## Concept Report Form

<b>Project Name</b>	SR 138 – Bridge over Overflow								
<b>PIN</b>	134864.00								
<b>Route Information</b>	<b>Route</b>	<b>NHS (Y/N)</b>	<b>Functional Class</b>			<b>City</b>		<b>County</b>	
	SR138	No	Rural Major Collector					Madison	
<b>Project Information</b>	<b>Begin Log Mile</b>	<b>End Log Mile</b>	<b>AADT<sup>1</sup></b>	<b>Design Hour Vol. (DHV)<sup>1</sup></b>	<b>Truck %<sup>1</sup></b>	<b>Design Speed (MPH)</b>	<b>Posted Speed (MPH)</b>	<b>Base Year</b>	<b>Design Year</b>

**SR-138 BRIDGE [57SR1380007]  
BRIDGE OVER OVERFLOW  
L.M. 4.69**

FIGURE 1  
S.R. 138  
L.M. 4.69

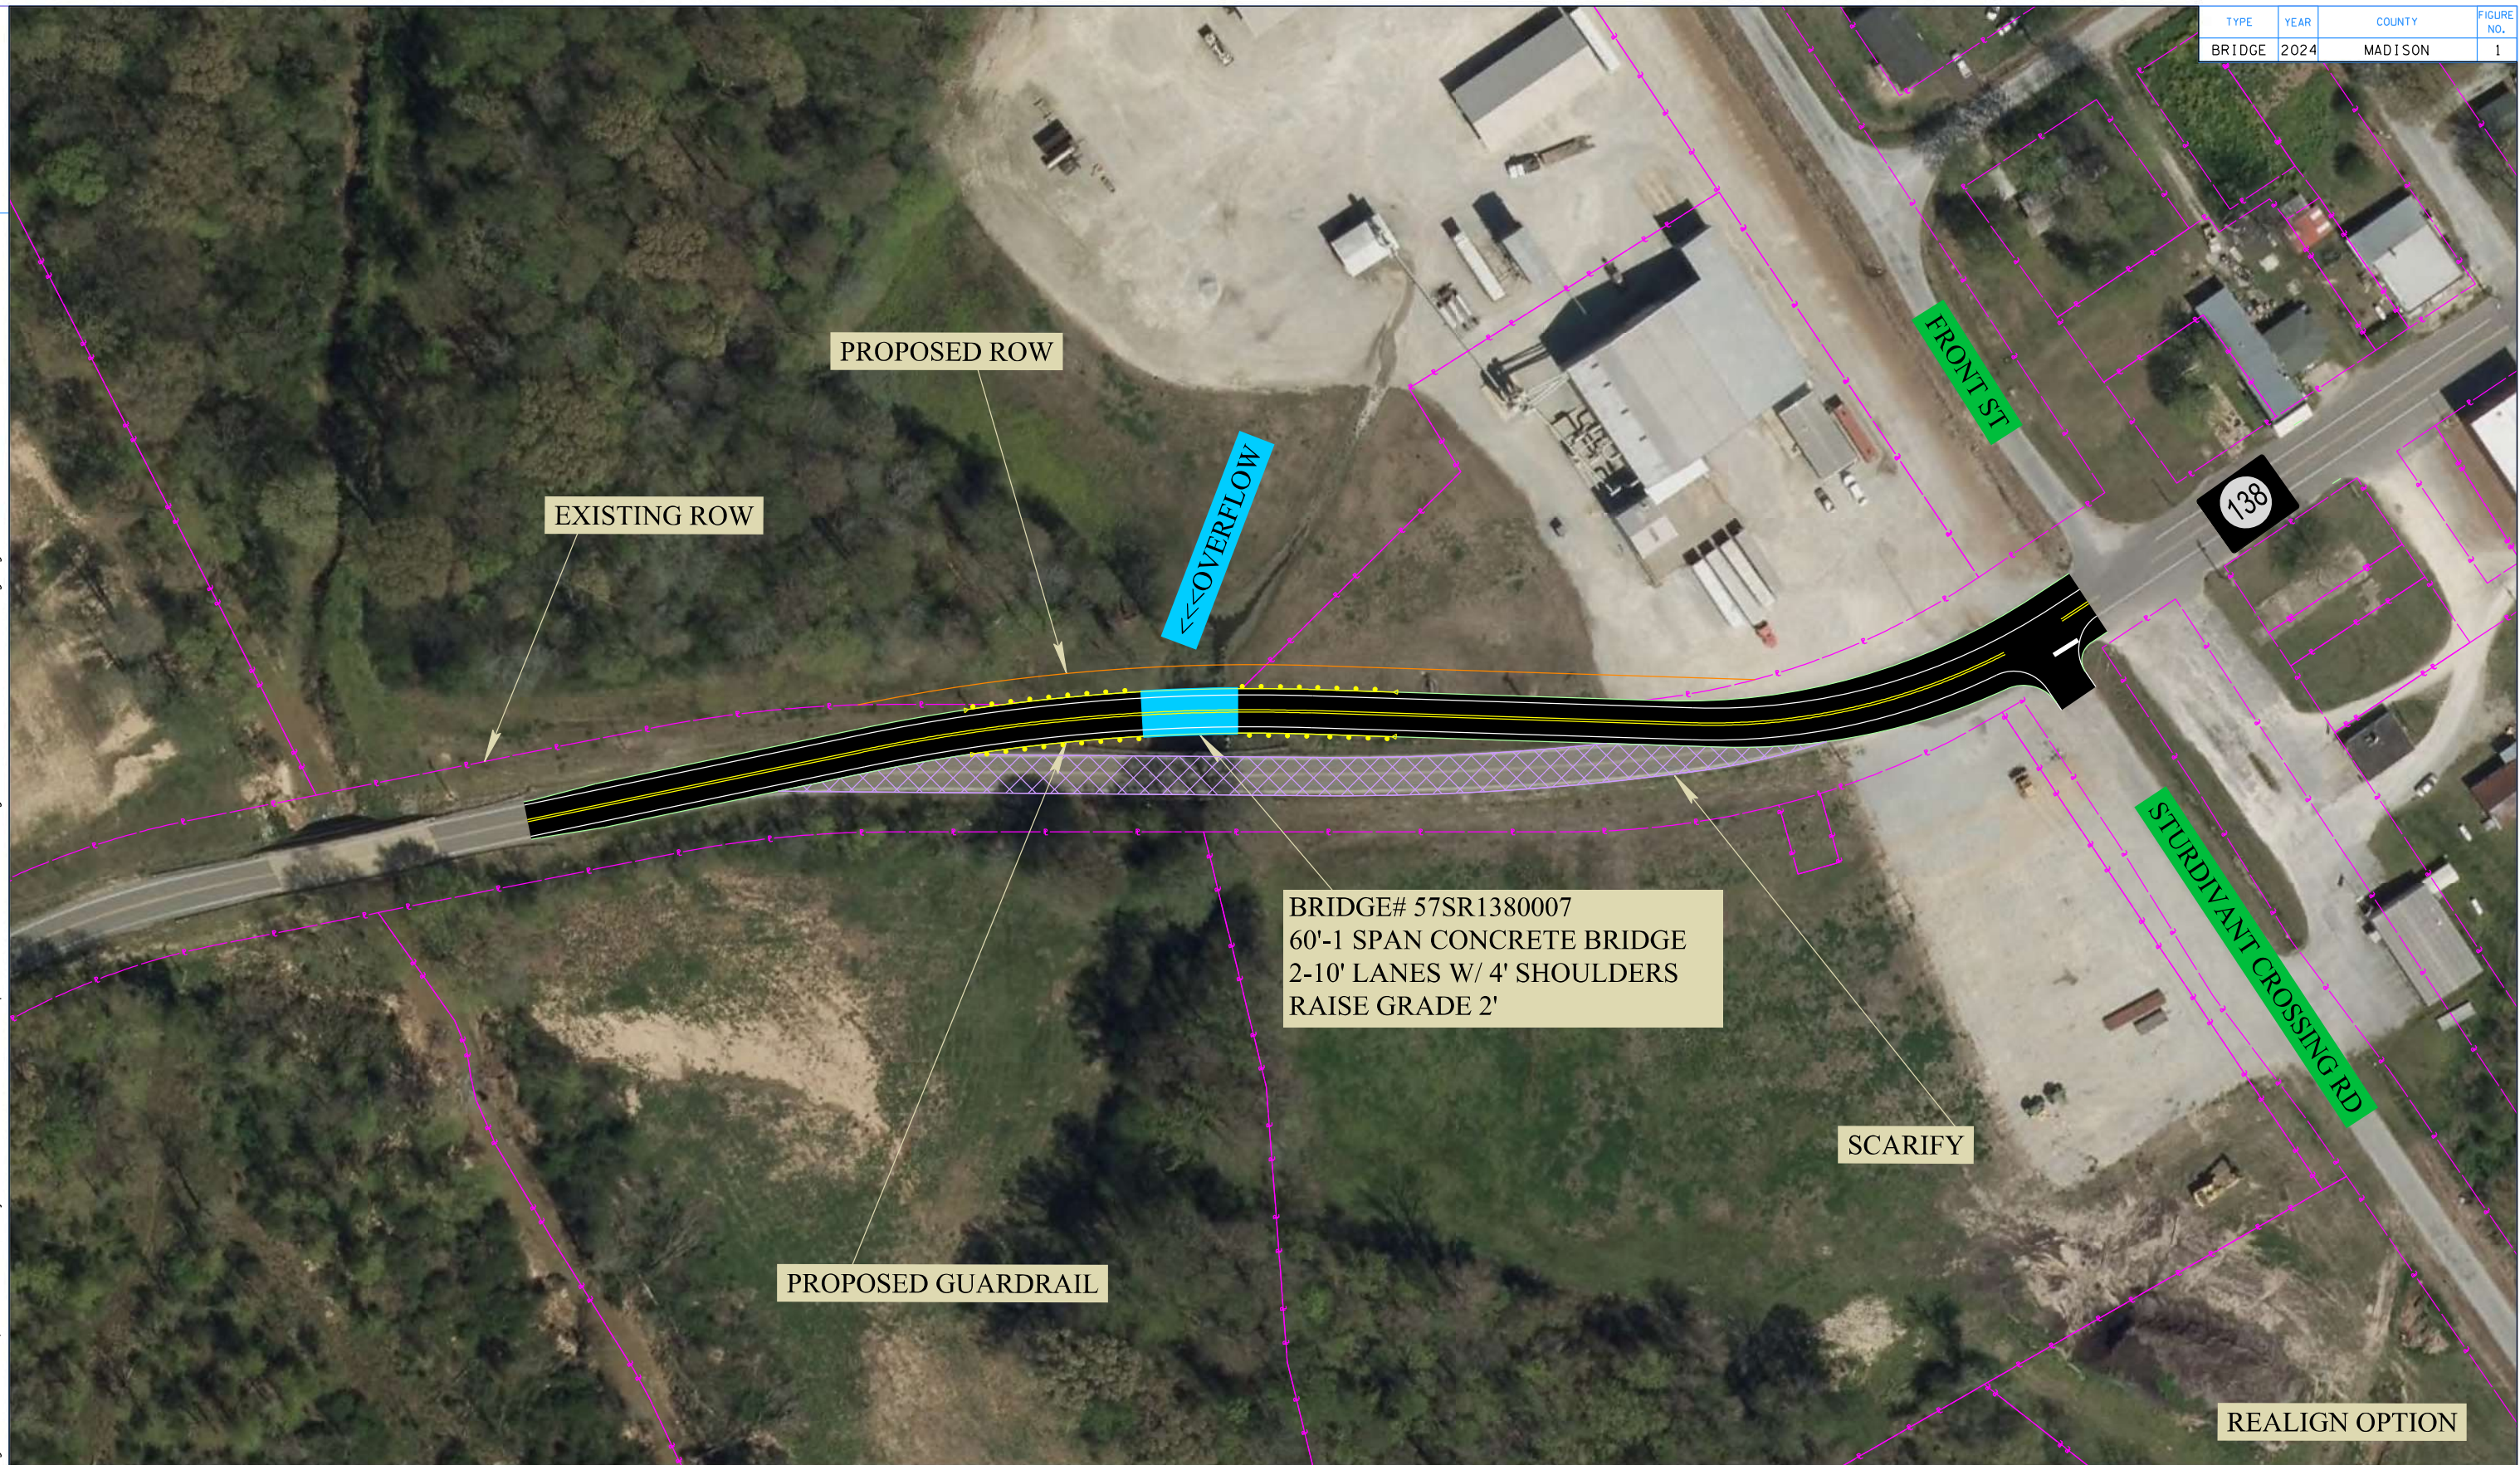
Comment Stage	Division	Commenter	Date	Comment	Comment Addressed?	Additional Notes
Draft Report Review (OSD2)	Design	Samuel Reed	5/14/2024	Detour route may not be necessary. In the ABC case, phase construction may be possible. In the case of an alignment shift, preconstruction and connection may be possible.	No	Detour was selected as the preferred recommendation due to budgetary constraints and traffic operations general recommendations. The PDN team will be able to further explore the feasibility different options.
Draft Report Review (OSD2)	Design	Samuel Reed	5/14/2024	This project calls for raising the grade two feet. This may result in addition enviromental impact.	Yes	The ETSA boundary provided in the report accounts for the raise in grade.
Draft Report Review (OSD2)	Design	Samuel Reed	5/14/2024	The proposed realignment puts the bridge in a horizontal curve. Avoid using Superelevation on the bridge deck.	No	We have avoided superelevation transitions with the proposed alignment, but full super on the bridge may be necessary to avoid replacing the adjacent structure and to minimize approach work.
